Anderson County Planning Commission

Tuesday, March 12, 2019
Regularly Scheduled Meeting
6:00 PM

Staff Report – Preliminary Subdivision

Preliminary Subdivision Name: Spencer's Trail (Previously Preston Trails)

Proposed Spencer's Trail

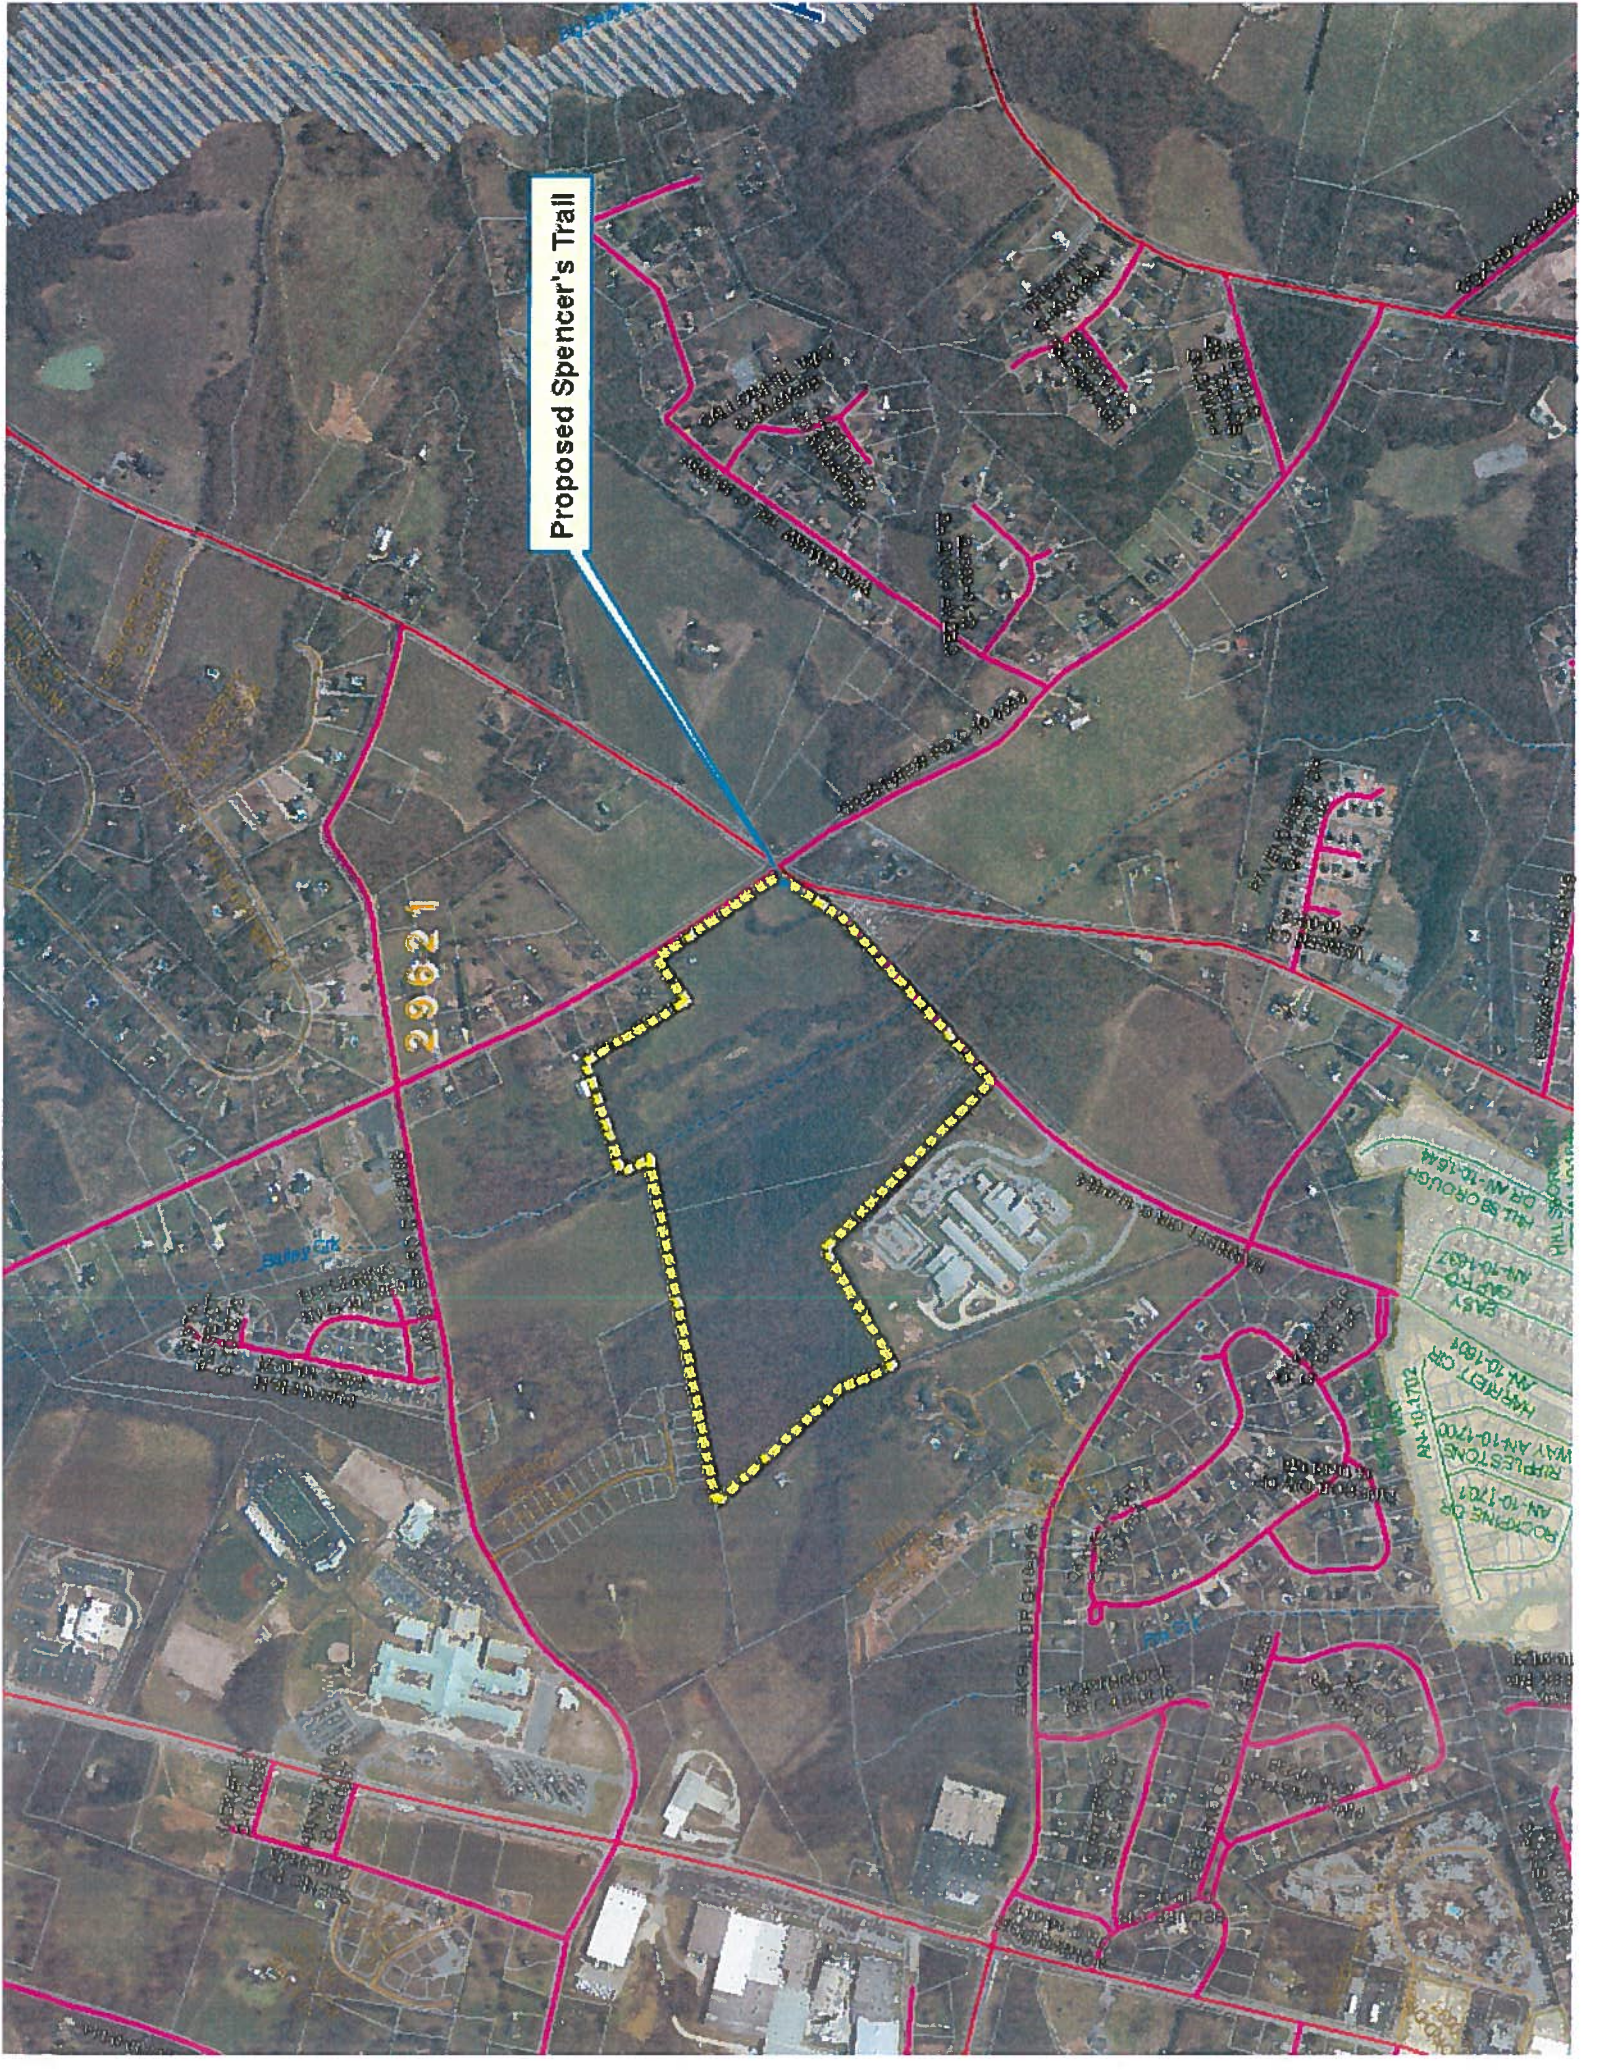
Crestview Road, Midway Road, Oak Hill Drive, and Harriett Circle are all classified as collector roads and do not have an average daily trip(ADT) restriction per section 38-118 Intensity Standards. Table 7 on page 20 of the traffic impact study(TIS) shows the predicted ADT on these roads to range from 23%-58% of the daily capacity. The level of service (LOS) does decrease from level A to B on the section of Crestview Road between Midway Road and Vandiver Road. The level of service on Harriett Circle decreases from level B to C on the section between the proposed entrance to Oak Hill Drive. However, most of the increased ADT is a result of the predicted 18% traffic growth rate from 2018-2023. For example, on the section of Harriett Circle from access 2 to Oak Hill Drive the proposed development is expected to add 243 trips per day; however, the background traffic growth adds 990. Furthermore, the traffic added by the development is only responsible for 3.6% of the total traffic(ADT) on this section.

Table 5 on page 17 of the TIS shows the existing capacity problem at the intersection of Crestview and Midway Road. The existing level of service(s) being D,E, and F indicates a need for some improvement. Table 16 on page 29 of the TIS shows that the proposed roundabout project will improve the level of service to A or B.

Page 22 of the TIS shows that the proposed access points on Harriett Circle and Crestview Road do not meet SCDOT guidelines for left lanes into the development. If the intersection of the advancing and opposing volumes plots to the left of the left turn percentage curves, then a left turn lane is not warranted by the SCDOT guidelines. At access 1 in the am the TIS predicts 2.2% left turns and the volumes plotted would intersect the left turn curve at about 7% so the warrant is not met. At access 1 in the pm the TIS predicts 14% left turns and the volumes plot in the shaded area to the left of the 40% curve, therefore, the warrant

is not met. Left turns on Harriett Circle into access 2 in the pm are estimated to be 10.4% but the volumes would require about 35% left turns to meet the warrant.

Page 23 of the TIS reviews the need for a right turn lane into the proposed development. The highest right turn volume into the development is predicted in the pm at access 2. There are 47 right turns and a total DHV of 250 which plots well below the line therefore, no right lane is required. It would take at least 87 right turns to meet this warrant for the estimated DHV.

The proposed traffic circle/island in the intersection of Meadow View Road and Forest Edge Road will need to be redesigned with a standard 4 way intersection during the construction plan approval process by Roads & Bridges.
